SANTA MONICA-MALIBU UNIFIED SCHOOL DISTRICT MALIBU HIGH SCHOOL - PHASE 1

DATE: 02/24/2022
DSA SUBMITTAL
COVER SHEET

BIOLOGY REVIEW REFERRAL SHEET

BIOLOGY REVIEW SHEET

Planting Plan for Downstream ESHA (Phase 1)

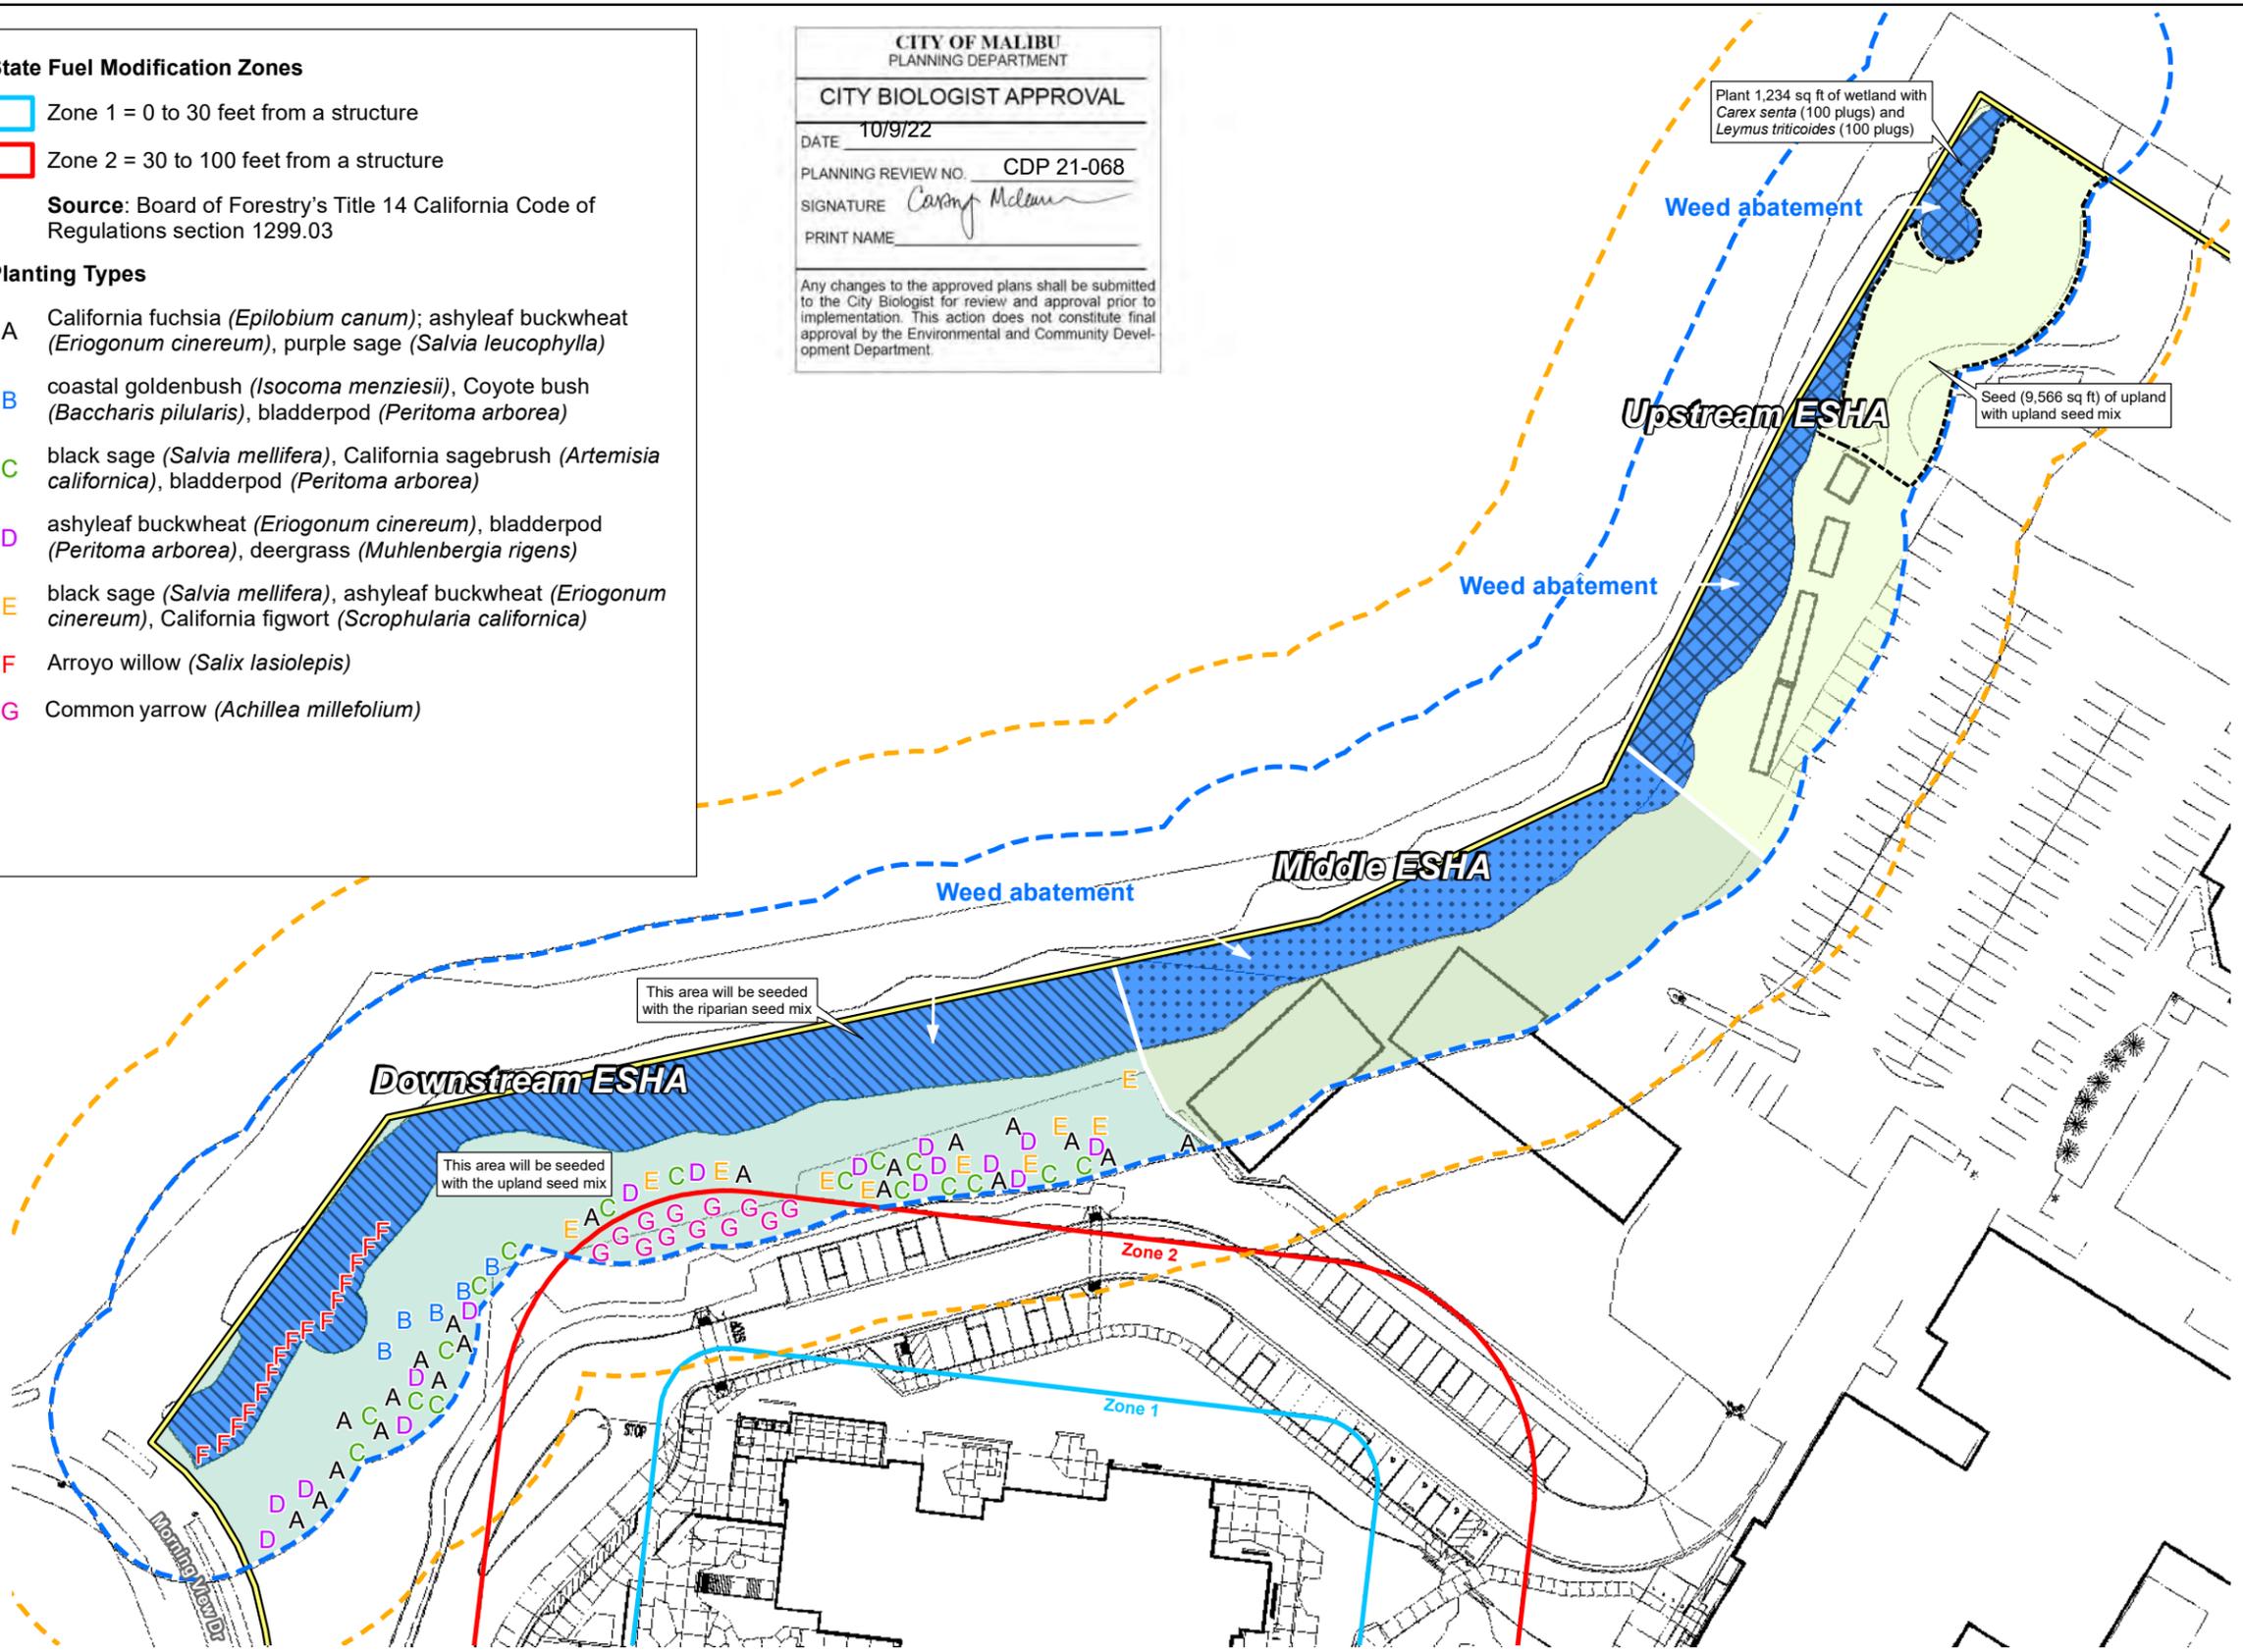
- G. Invasive plant species, as determined by the City of Malibu, are prohibited. The submitted plan includes the use of *Carex tumulicola*. This native species is often confused or interchanged with the invasive and non-native *Carex divulsa*. Please ensure only the native *C. tumulicola* is utilized. If there is any indication that *C. divulsa* is on site it will require removal at the applicant's expense.

Any changes to the approved plans shall be submitted to the City Biologist for review and approval prior to implementation. This action does not constitute final approval by the Environmental and Community Development Department.

FIRE DEPARTMENT ACCESS SITE PLAN

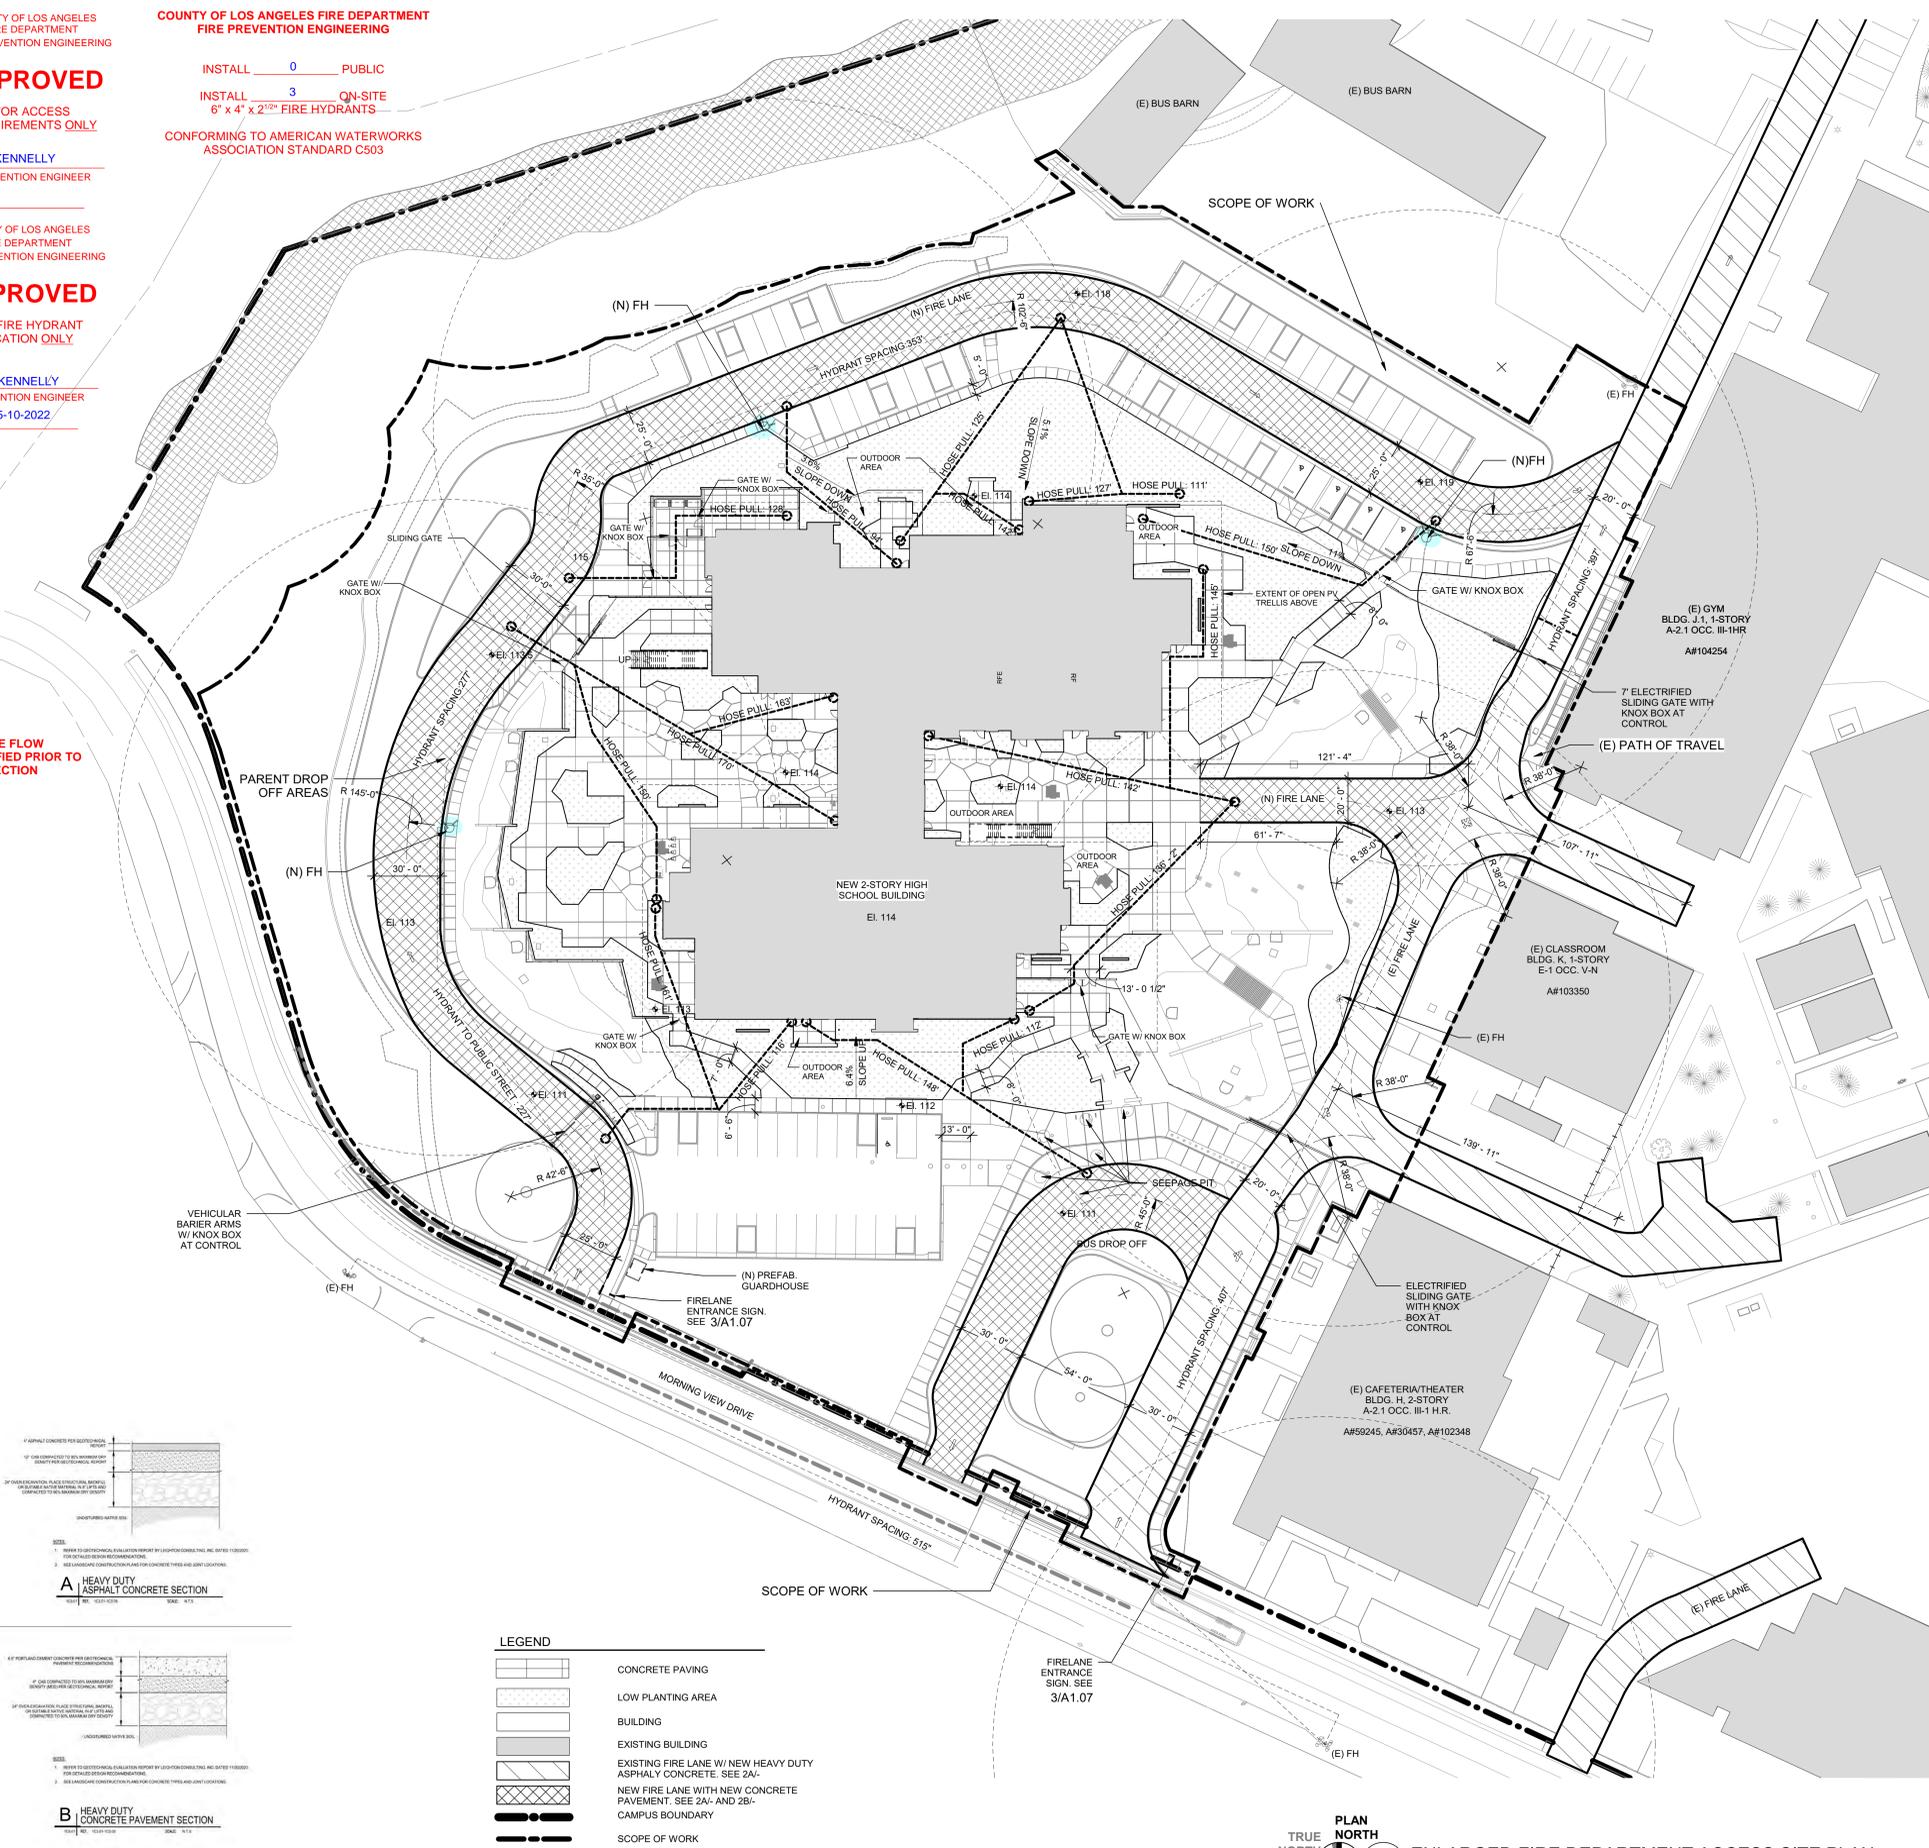
The required fire flow for this project is 1500 gallons per minute at 20 pounds per square inch for a 1 hour duration. (Provide flow information from the water dept.)

- SIGNAGE**
PROVIDE FIRE DEPARTMENT APPROVED SIGNS THAT INCLUDE THE WORDS "NO PARKING" - FIRE LANE SHALL HAVE A MINIMUM DIMENSION OF 12'W X 18'H AND HAVE RED LETTERS ON A WHITE REFLECTIVE BACKGROUND. SEE 1'- AND DETAIL 3/A1.07.
SIGNS SHALL BE PROVIDED FOR FIRE APPARATUS ACCESS ROADS, TO CLEARLY INDICATE THE ENTRANCE TO SUCH ROAD, OR PROHIBIT THE OBSTRUCTION THEREOF AND AT INTERVALS, AS REQUIRED BY THE FIRE INSPECTOR. FIRE CODE 503.3.

- FIRE DEPARTMENT ACCESS ROAD**
PROVIDE A MINIMUM UNOBSTRUCTED WIDTH OF AT LEAST 20 FEET, IN ACCORDANCE WITH SECTION 503.8, AND AN UNOBSTRUCTED VERTICAL CLEARANCE "CLEAR TO SKY" FIRE DEPARTMENT VEHICULAR ACCESS TO WITHIN 150 FEET OF ALL PORTIONS OF THE EXTERIOR WALLS OF THE FIRST STORY OF THE BUILDING, AS MEASURED BY AN APPROVED ROUTE AROUND THE EXTERIOR OF THE BUILDING.
FIRE APPARATUS ACCESS ROADS SHALL BE DESIGNED AND MAINTAINED TO SUPPORT THE IMPOSED LOAD OF FIRE APPARATUS WEIGHING 75,000 LBS. AND SHALL BE SURFACED SO AS TO PROVIDE ALL-WEATHER DRIVING CAPABILITIES. SEE ROADWAY DETAILS 2A/- AND 2B/-
FIRE APPARATUS ACCESS ROADS HAVING A GRADE OF 10% OR GREATER SHALL HAVE A PAVED OR CONCRETE SURFACE. FIRE CODE 503.2.3

APPROVED
FOR FIRE HYDRANT
LOCATION ONLY
